AMENDMENTS TO THE FY 2020/2021 THROUGH FY 2024/2025 TRANSPORTATION IMPROVEMENT PROGRAM TO ADD A WRONG WAY DRIVING PROJECT AND TO ADJUST THE 5305 FUNDING

RECOMMENDED ACTION: Amend the Transportation Improvement Program (TIP) to add a wrong way driving safety project at various off ramps and to adjust the FTA 5305 transit planning funds to remove the state and local funding (**attached** are the draft TIP pages, the FDOT request letter and additional information on the wrong way driving project counter measures).

TRAFFIC ENGINEERING AND OPERATIONS BULLETIN 19-03 ROADWAY DESIGN BULLETIN 19-03 PROGRAM MANAGEMENT BULLETIN 19-03 CONSTRUCTION BULLETIN 19-01

SUBJECT: **Wrong-way Driving Advanced Countermeasures at Interchange Exit Ramps**

TYPICAL LAYOUT FOR DIAMOND INTERCHANGE EXIT RAMP

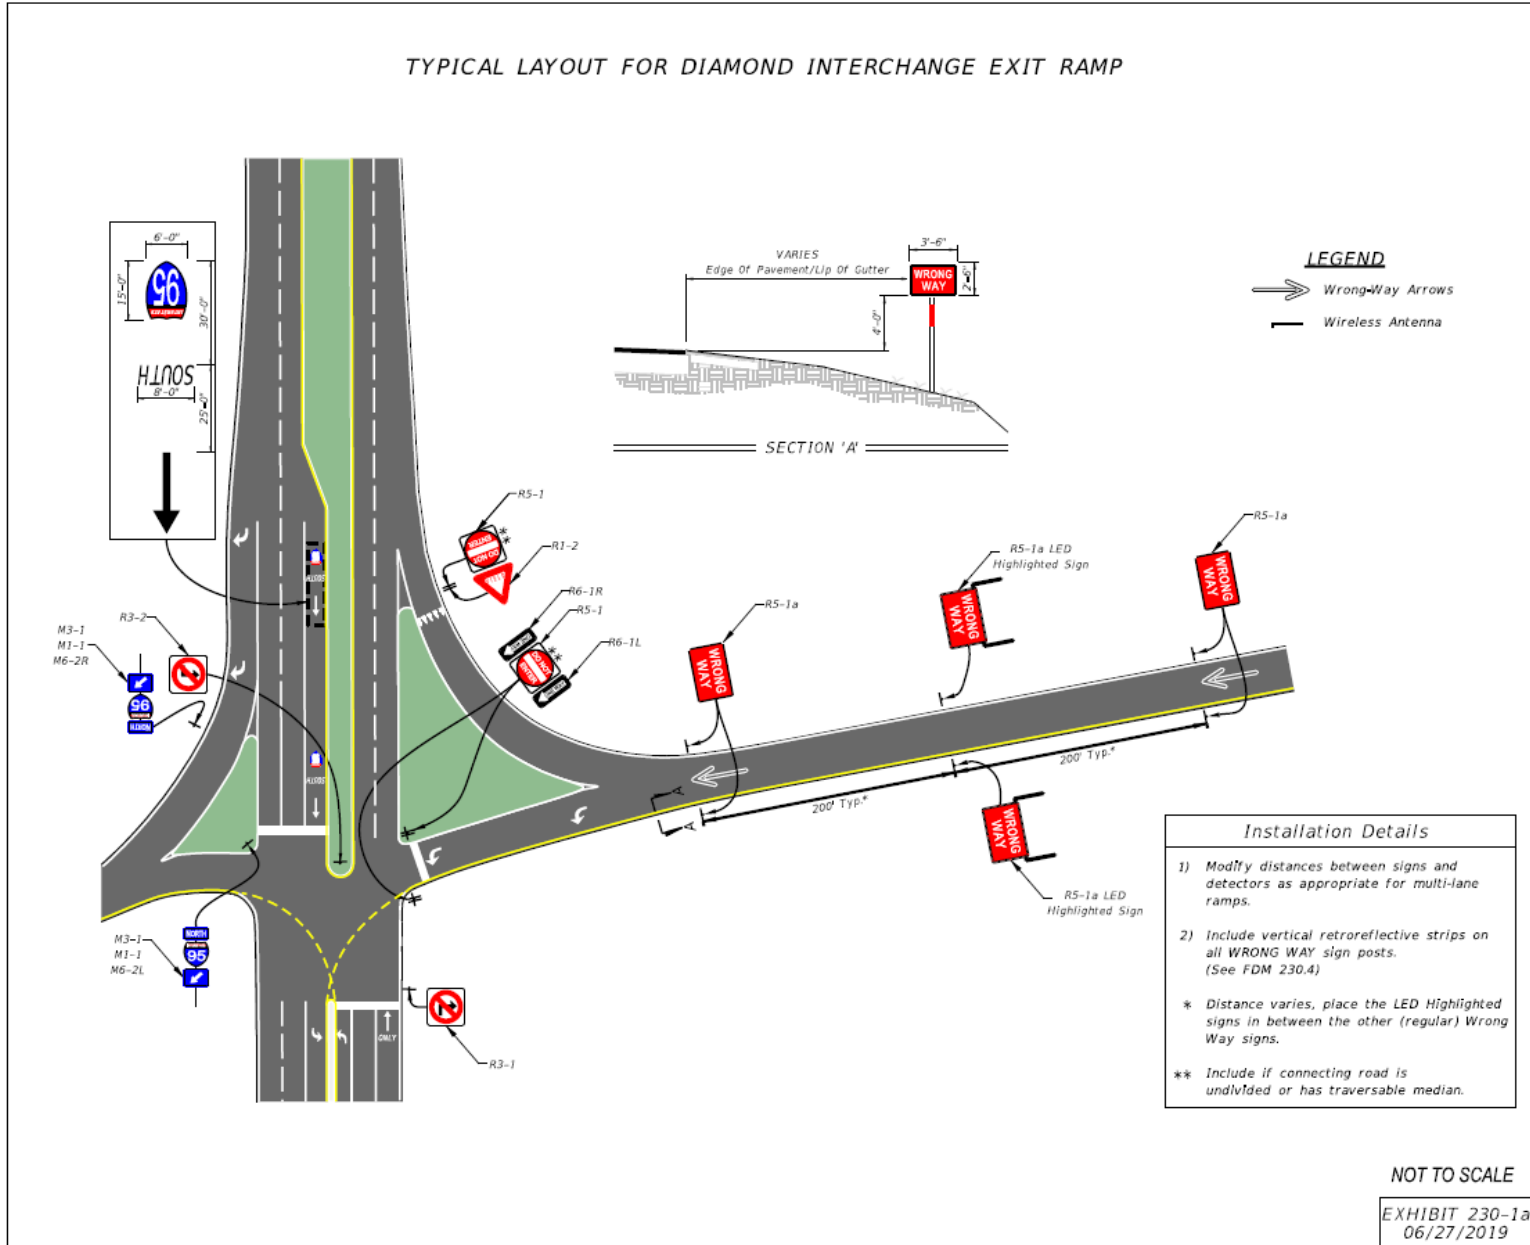
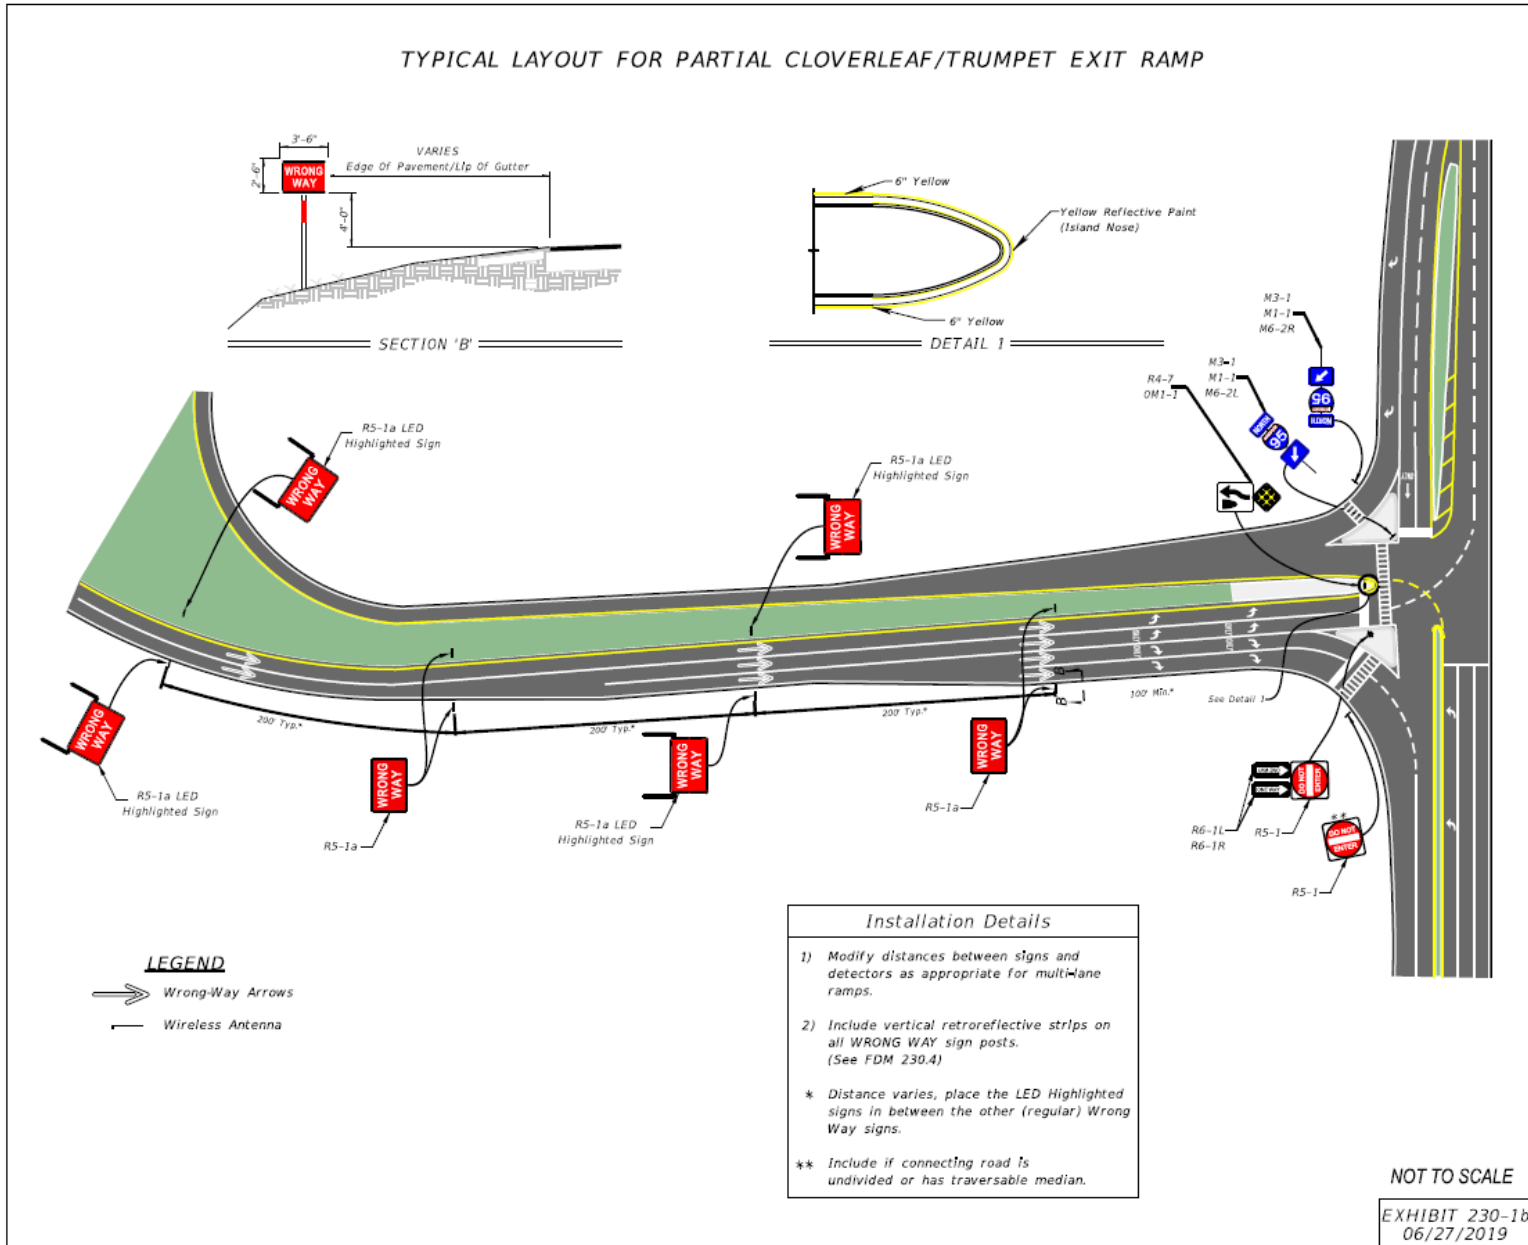
2. Replace ***FDM Exhibit 230-1*** with the corresponding exhibits in Attachment ‘B’.

The standard for signing and pavement marking and advanced countermeasure installation at exit ramp intersections are illustrated in Exhibit 230-1a and 230-1b. The description of the layouts are as follows:

- 1) Include MUTCD “optional” signs; second DO NOT ENTER, second WRONG WAY sign, and ONE WAY signs.
- 2) Include NO RIGHT TURN and NO LEFT TURN signs.
- 3) Use 3.5 feet by 2.5 feet WRONG WAY signs mounted at four-foot height and include a retroreflective strip on sign supports.

- 4) Include 2-4 dotted guide line striping for left turns between ramps entrances/exits and cross-streets.
- 5) Include retroreflective yellow paint on ramp median nose where applicable.

- 6) Include a straight arrow and route shield pavement marking in left-turn lanes extending from the far-side ramp intersection through the near-side ramp intersection to prevent premature left turns. Refer to TEM, Section 4.2.4 “Route Shields for Wrong Way Treatment” for additional information.

- 7) Include a straight arrow and ONLY pavement message in outside lane approaching the ramp exit.
- 8) Install a pair of Light-emitting Diode (LED) Highlighted Wrong-Way Signs. For long ramps or for ramps with limited sight distance, two sets of the pairs of Highlighted Signs may be used, as illustrated in ***Exhibits 230-1a*** and ***230-1b***. The Highlighted Sign assembly may be powered by either solar or line power. If line power is used, include the power service assembly and conduit and cable from the Highlighted Sign to the service point. The Highlighted Sign shall be integrated back to the District’s Traffic Management Center (TMC). Connectivity between the Highlighted Sign and the TMC may be provided by either fiber optic or wireless communications. If fiber optic communications are used, include the fiber optic cable, conduit, and transmission equipment. If wireless communications are used, include the antenna and transmission equipment.

Figure 7.2.1 Typical Layout for Diamond Interchange Exit Ramp

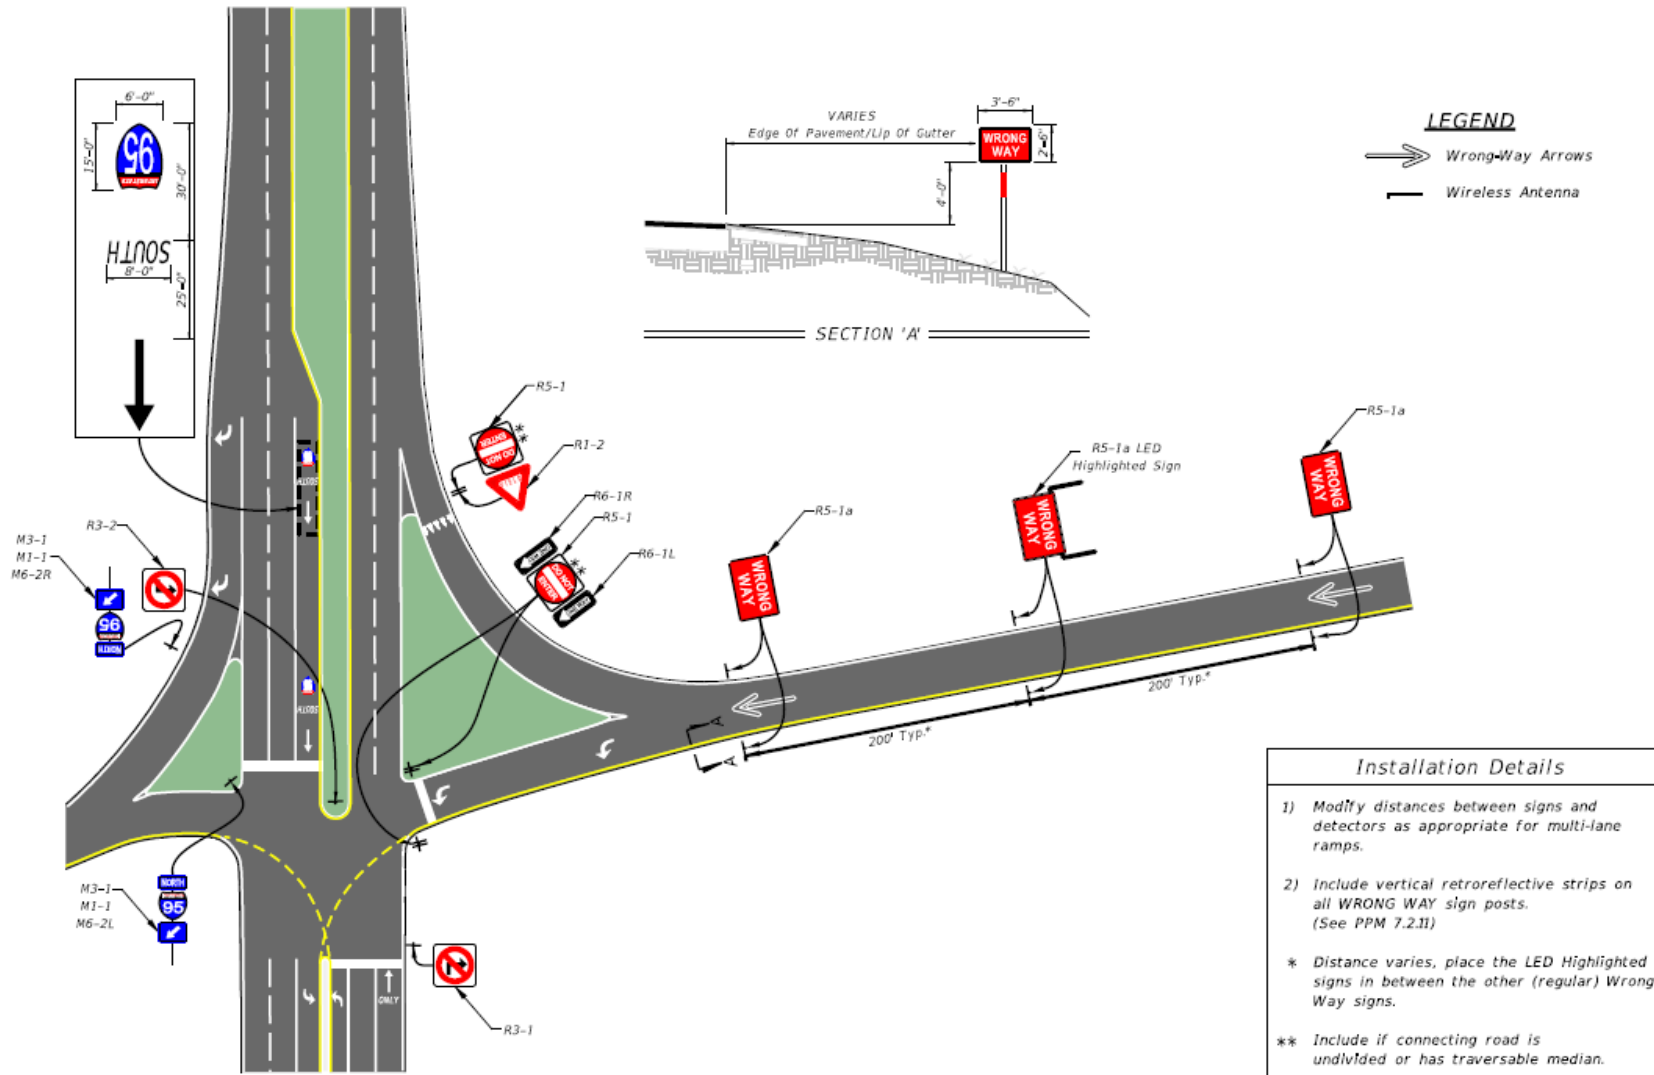
2. Replace *PPM Figures 7.2.1* and *7.2.2* with the corresponding figures in Attachment ‘C’.

The standard for signing and pavement marking and advanced countermeasure installation at exit ramp intersections are illustrated in Figures 7.2.1 and 7.2.2. The description of the layouts are as follows:

- 1) Include MUTCD “optional” signs; second DO NOT ENTER, second WRONG WAY sign, and ONE WAY signs.
- 2) Include NO RIGHT TURN and NO LEFT TURN signs.
- 3) Use 3.5 feet by 2.5 feet WRONG WAY signs mounted at four-foot height and include a retroreflective strip on sign supports.

- 4) Include 2-4 dotted guide line striping for left turns between ramps entrances/exits and cross-streets.
- 5) Include retroreflective yellow paint on ramp median nose where applicable.

- 6) Include a straight arrow and interstate shield pavement marking in left-turn lanes extending from the far-side ramp intersection through the near-side ramp intersection to prevent premature left turns. Refer to TEM, Section 4.2.4 “Route Shields for Wrong Way Treatment” for additional information.

- 7) Include a straight arrow and ONLY pavement message in outside lane approaching the ramp exit.
- 8) Install a pair of Light-emitting Diode (LED) Highlighted Wrong-Way Signs. For long ramps or for ramps with limited sight distance, two sets of the pairs of Highlighted Signs may be used, as illustrated in **Figures 7.2.1** and **7.2.2**. The Highlighted Sign assembly may be powered by either solar or line power. If line power is used, include the power service assembly and conduit and cable from the Highlighted Sign to the service point. The Highlighted Sign shall be integrated back to the District’s Traffic Management Center (TMC). Connectivity between the Highlighted Sign and the TMC may be provided by either fiber optic or wireless communications. If fiber optic communications are used, include the fiber optic cable, conduit, and transmission equipment. If wireless communications are used, include the antenna and transmission equipment.
